TENNESSEE VALLEY AUTHORITY

RESPONSE TO THOMAS M. NOVAK'S SEPTEMBER 17, 1982 LETTER
TO H. G. PARRIS REQUESTING ADDITIONAL INFORMATION
ON HYDROGEN CONTROL FOR ICE CONDENSER PLANTS

SEQUOYAH NUCLEAR PLANT

RESPONSE TO
REQUEST FOR ADDITIONAL INFORMATION
ON HYDROGEN CONTROL FOR ICE CONDENSER PLANTS

MAXIMUM GAS CONCENTRATION DIFFERENCE FOR TEST HM-1A, HM-2, HM-4C, AND HM-6

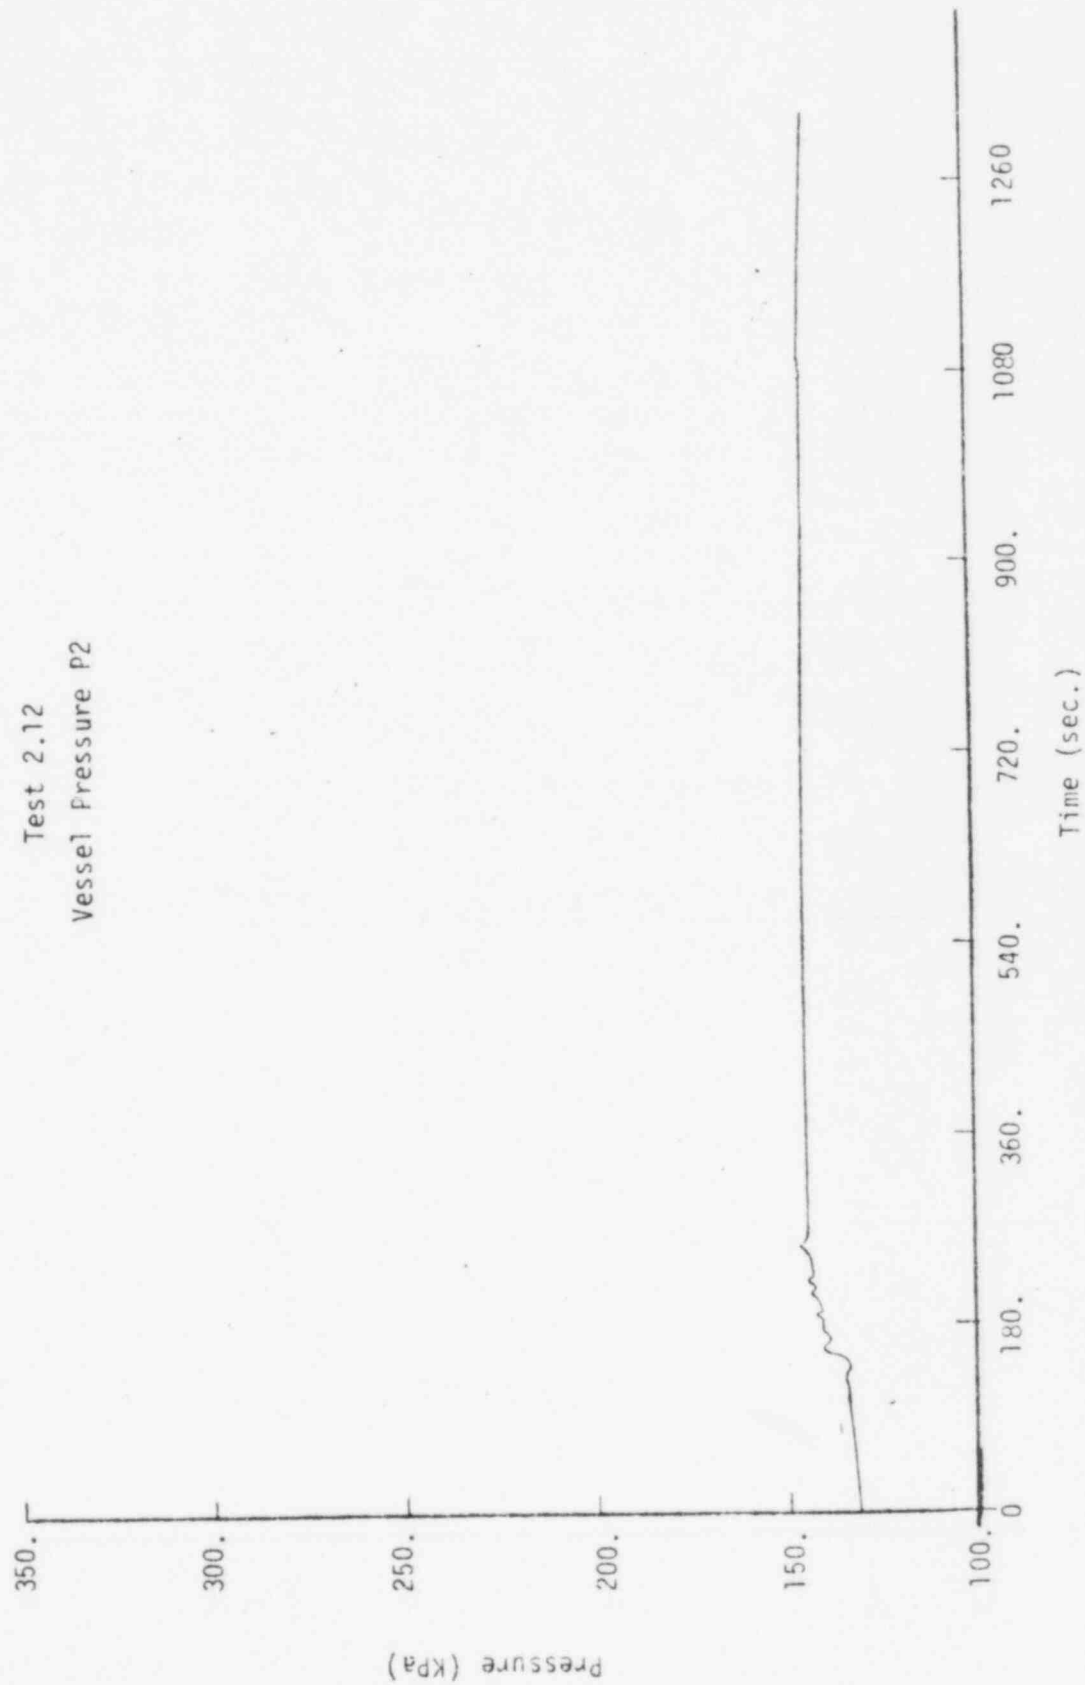
- i) A table of droplet size and droplet density estimates for each of the fog/spray tests.
- ii) A table of estimated flame speed for each test (flame speed should be calculable from thermocouple locations and ignition time data).
- iii) Pressure and temperature traces similar to those depicted in Figures 4-2 of the December 1981 Acurex Project Report, but for tests 2.10, 2.11, and 2.12.

FIGURE 1

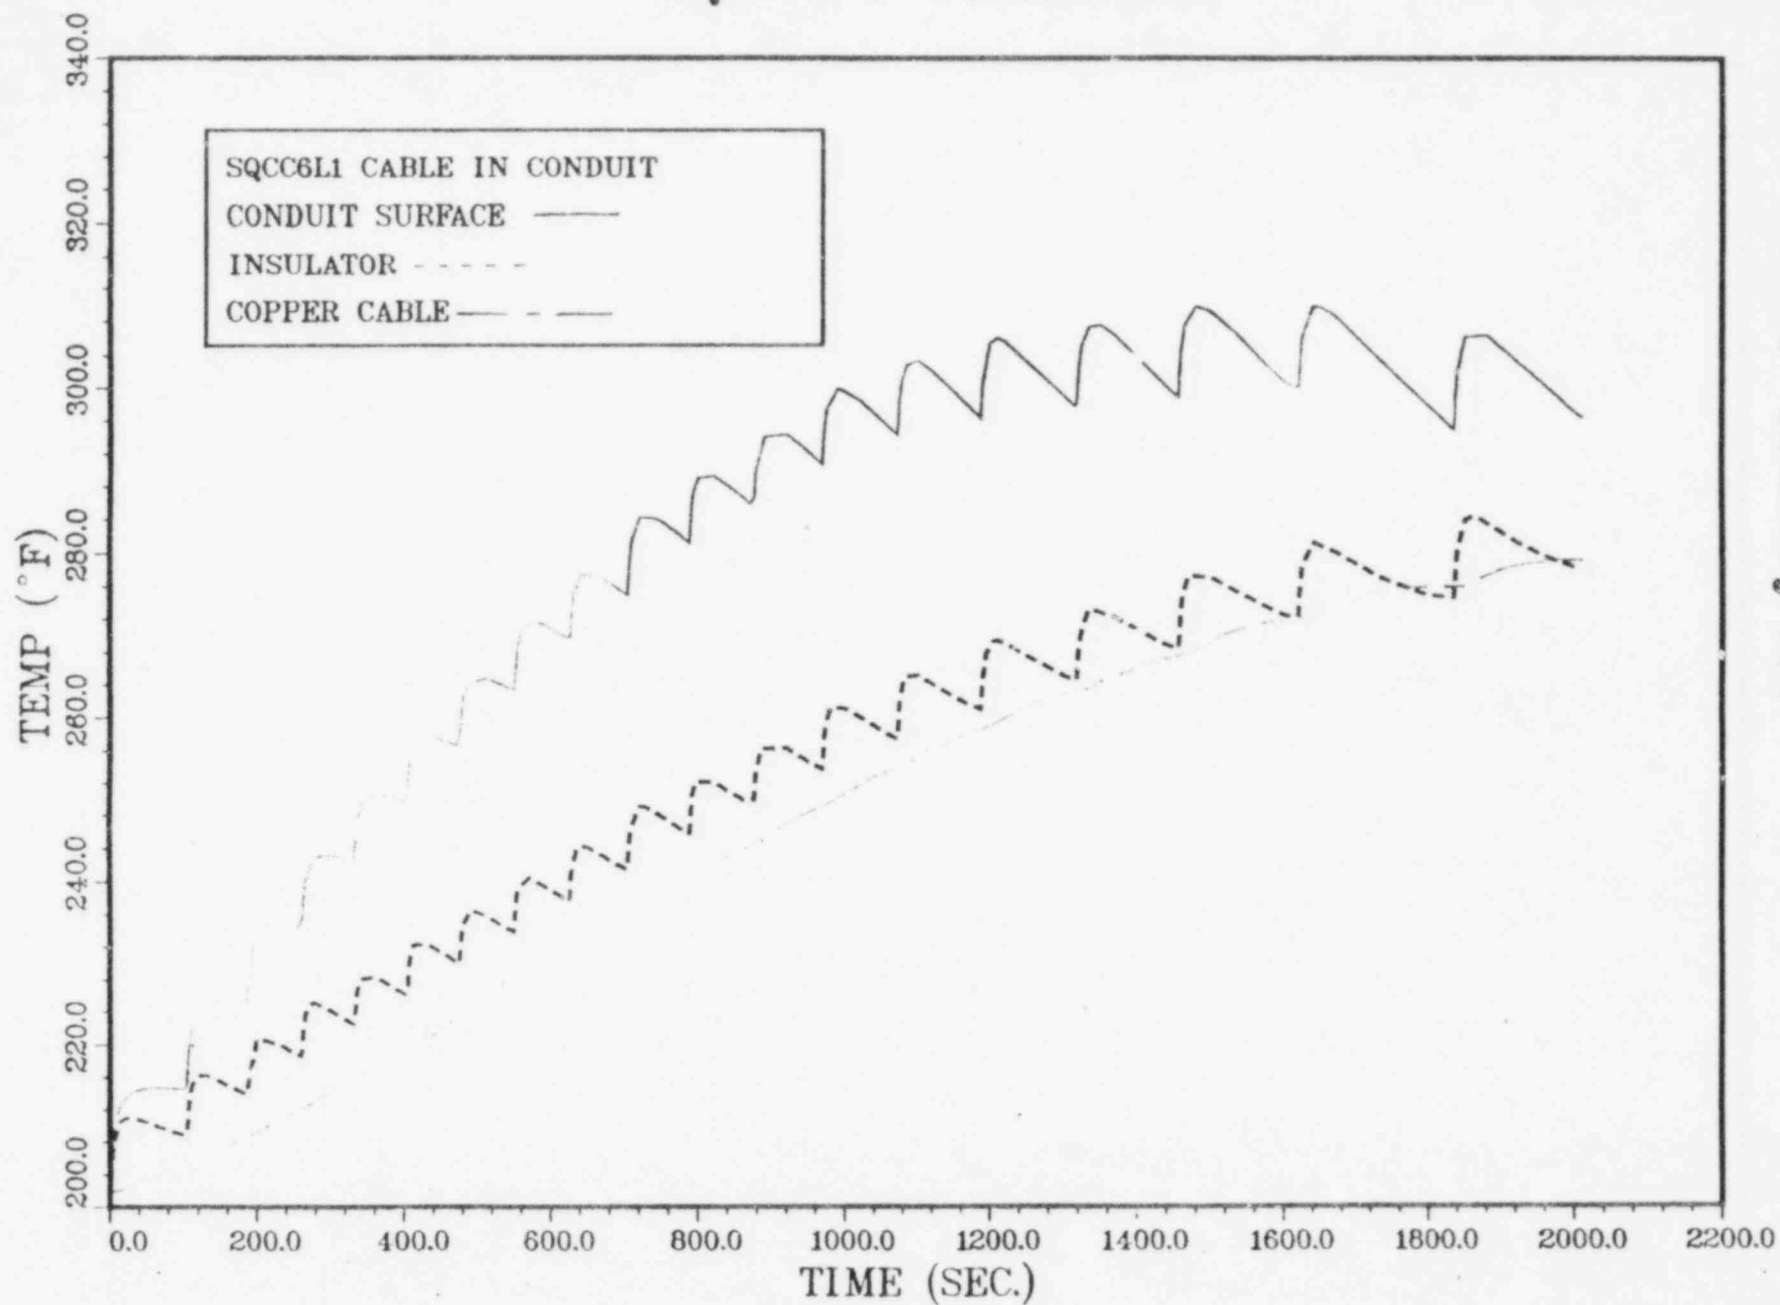
In your response to item 3 in your letter dated April 6, 1982, you indicated that for Case 1C the burns are of a much shorter duration and the ambient temperature is lower. The staff recognizes that the burns are of a shorter duration, but in addition to this duration between burns is also of much shorter duration which allows less time for the equipment to cooldown. Also, if the licensee wants to demonstrate the blowdown sensitivity studies (case JJ1) that containment integrity is maintained even for three times the mass flow rate used in S₂D scenario then it should also be demonstrated that equipment will survive for that scenario. Hence, provide the equipment temperature for these two cases.

The results of the thermal analysis of the cable in conduit for a burn criteria of 6 v/o-60% (CLASIX Case 1C) is provided on Figure 1. The response of the cable in conduit is provided as it is the most responsive to environmental changes of any of the equipment analyzed. The analysis shows that the maximum surface temperature is essentially the same as shown for the same 8 v/o-85% case on Figure 2-2.14 of our December 1, 1981, submittal. This analysis of CLASIX Case 1C very conservatively includes radiative heat transfer from the hot gas cloud during the burn at the adiabatic flame temperature and radiative heat transfer based on the CLASIX profile at all times during the transient. This essentially doubles the radiation heat transfer during the burn. In addition, to adding more conservatism the radiation term utilizing the CLASIX profile used gas and equipment surface emissivities of 1.0 (i.e., black body radiation) and view factors of 1.0. Natural convection was also included in the same manner as presented in the analysis discussed in our December 1, 1981, submittal. Even with these gross conservatis the same large margins in our earlier analyses still remain assuring the survivability of our equipment.
